**BASELINE MONITORING
DOCUMENT AND AS-BUILT
BASELINE REPORT
FINAL**

MARTIN DAIRY MITIGATION SITE

DMS Project Number 97087

RE: Draft As-Built Baseline Report Martin Dairy Mitigation Site, DMS ID# 97087
Neuse River Basin – CU# 03020201
Orange County, North Carolina
Contract No. 6831

1.4

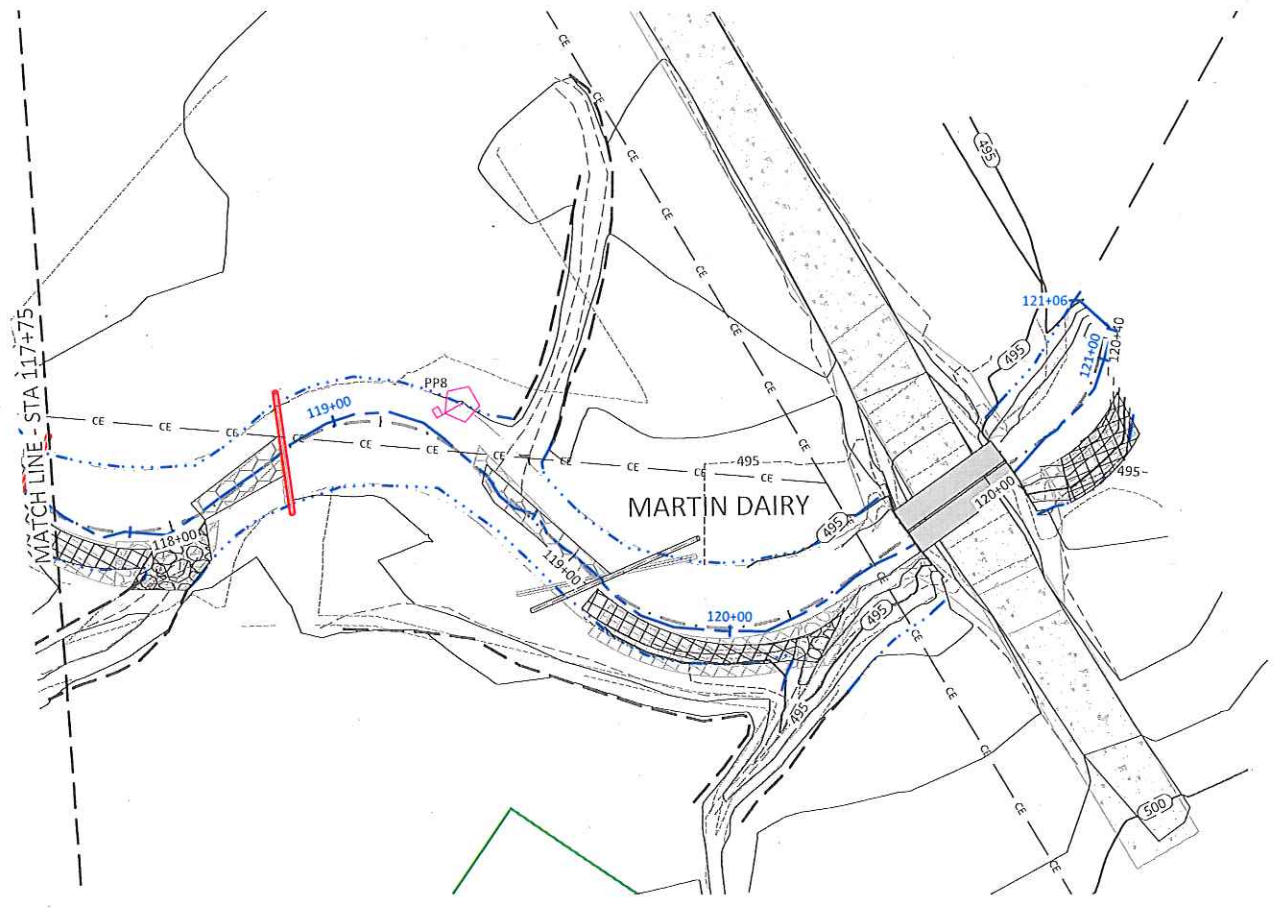
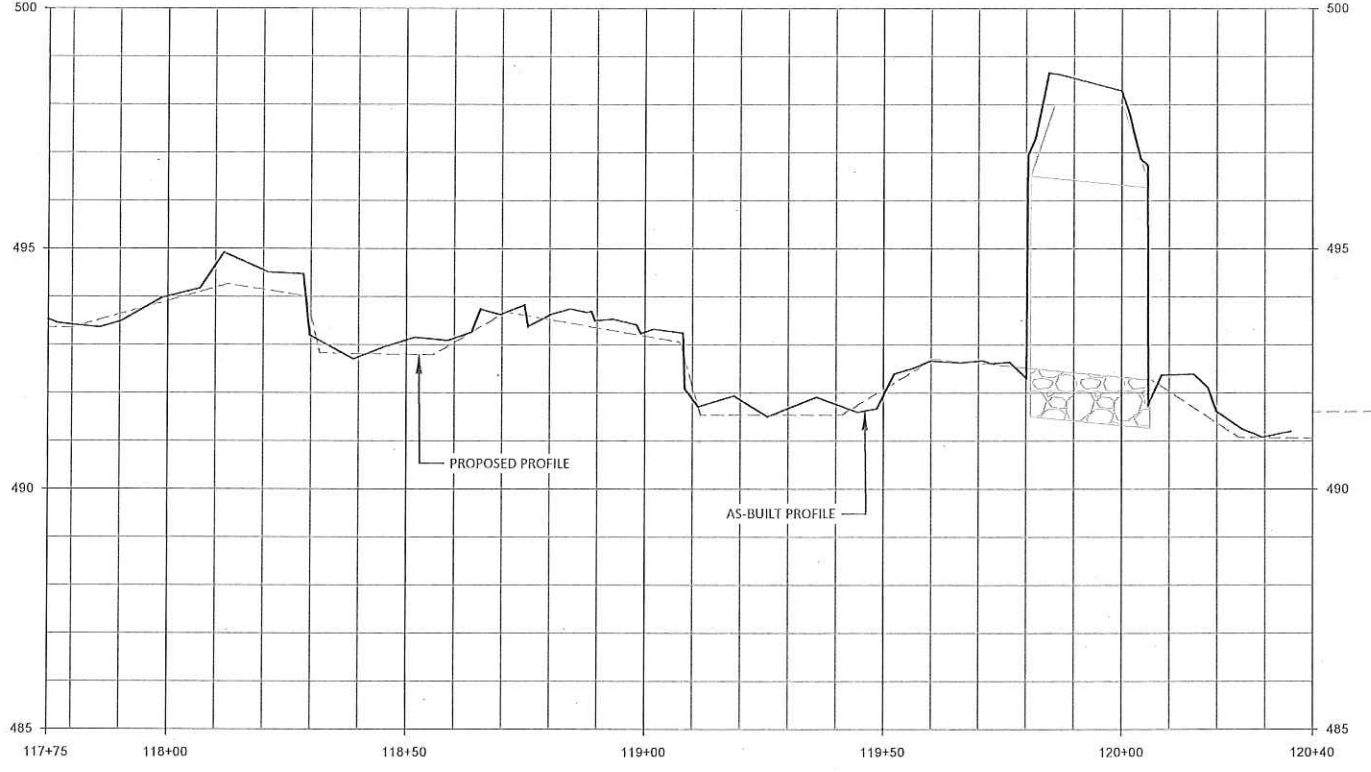
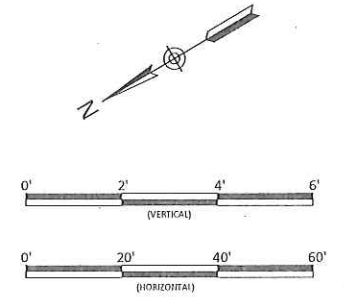
- a) Record Drawings: Show all changes from design in red, including but not limited to revised structure placement (i.e. log vane near station 103+00).

Any revisions from final construction plans are shown in red. If a structure is in the same location, but the angle of installation varies from that shown on the final construction plans, this is not shown in red (log vane near station 103+00). Rock sills that were exchanged for log sills have been changed to red in this submittal.

NOTE: AT MARTIN DAIRY STA. 118+88, BOULDER SILL WAS REPLACED WITH LOG SILL DUE TO FIELD CONDITIONS AND AVAILABILITY OF ONSITE MATERIAL.
